Western Energy Company's Rosebud Mine
Area B Extension

Final Environmental Impact Statement

Prepared by the Montana Department of State Lands

November, 1980

FIGURE II-3.--Annual geometric mean TSP concentrations in Colstrip, 1972-1979. Dashed line shows the Federal primary ambient air quality standard of 75 ug/m³. *1979 data are for January through April.

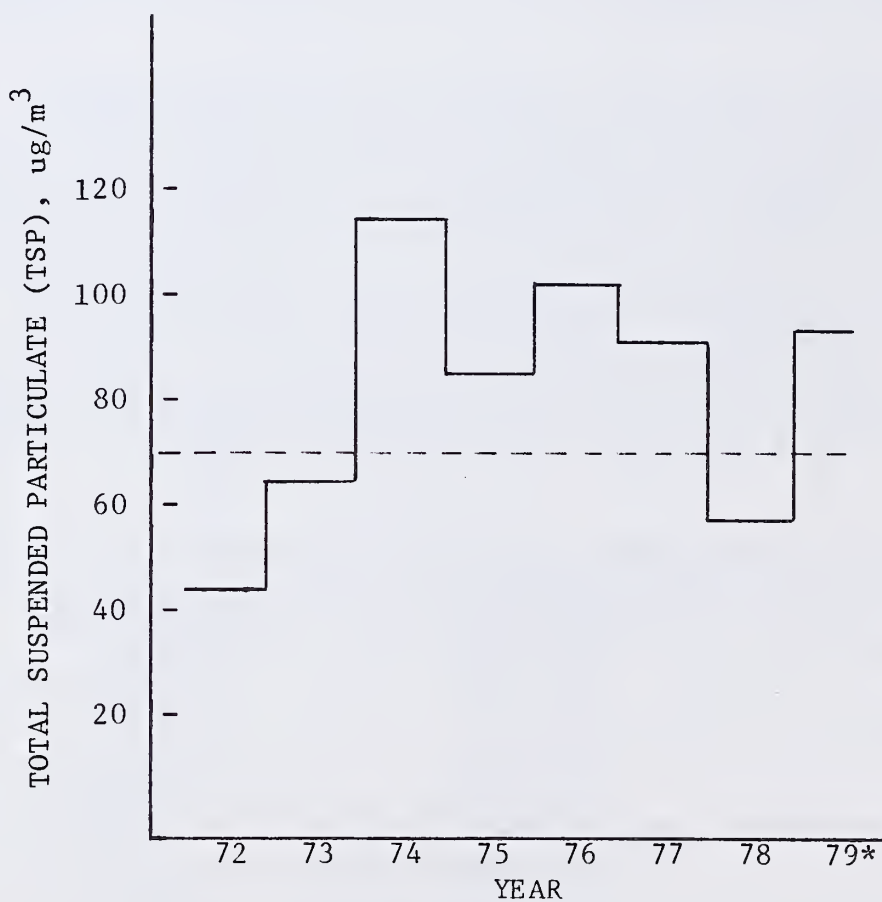
18 The declaration made in the first sentence of this paragraph regarding deterioration of air quality is erroneous and totally inconsistent with the data presented in Figure II-3 on page II-10.

This sentence should be deleted completely. What is the source of Figure II-3 on page II-10? How is "the immediate vicinity of Colstrip" defined as used in the last sentence of this paragraph? Is the proposed mining area included in the "immediate vicinity?" If not, the statement is not relevant.

Figure II-3 shows data from the IPC #3 site in the town of Colstrip. Those data most accurately represent ambient air conditions in the town, as stated in the DEIS. Area B could potentially add to air pollution in Colstrip, although its contribution is not known. For this reason the air quality of Colstrip is relevant to the analysis.

Figure II-3 shows that the geometric mean for the period 1972 through 1973 averaged 55 ug/m³ and did not exceed the Federal secondary ambient air quality standard (AAQS) of 60 ug/m³. For the period 1974 through April 1979 the TSP geometric mean was about 90 ug/m³ which exceeded both the Federal primary standard (75 ug/m³) and the secondary standard. This 64 percent increase in TSP concentrations represents a substantial deterioration in ambient air quality at Colstrip. To avoid possible confusion with the rules regarding prevention of significant deterioration, the first sentence of the cited paragraph has been changed to read "...has deteriorated substantially in the past 6 years."
